Amendment 39-2914; AD 77-12-01

Airworthiness Directives; Piper Models PA-28-235, PA-32-260, PA-32-300, and PA-32S-300 Airplanes

TIP TANK VENT TUBE

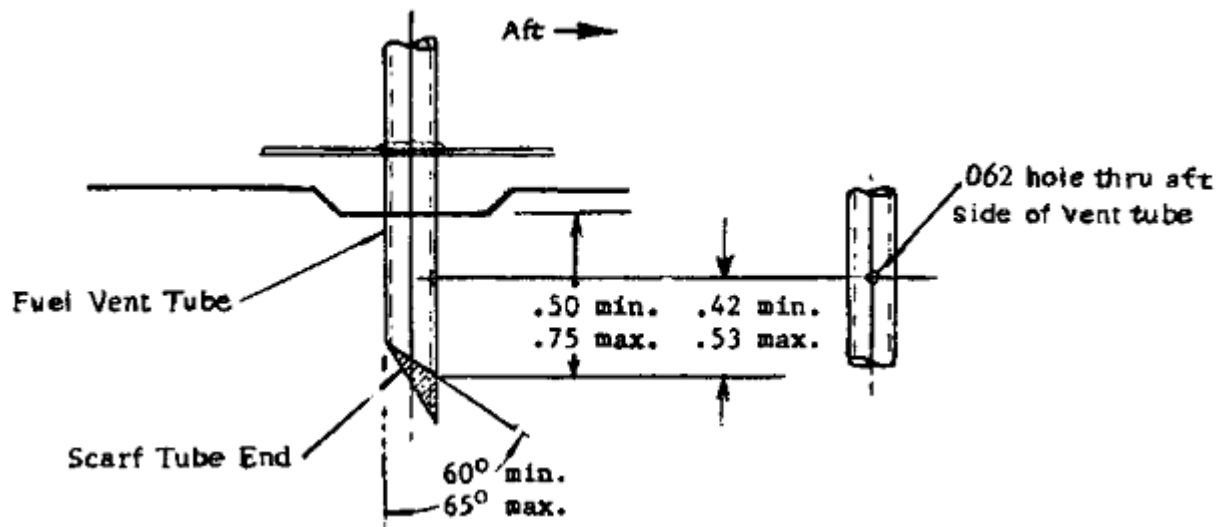
(1) Unless already accomplished, rework fuel tip tank vent to the dimensions shown on the sketch below:

(4) If the tip tank vent tube scarf angle is not between 60 degrees and 65 degrees, or if the vent tube is not perpendicular (90 degrees) plus or minus 2 degrees, rework it to those dimensions.
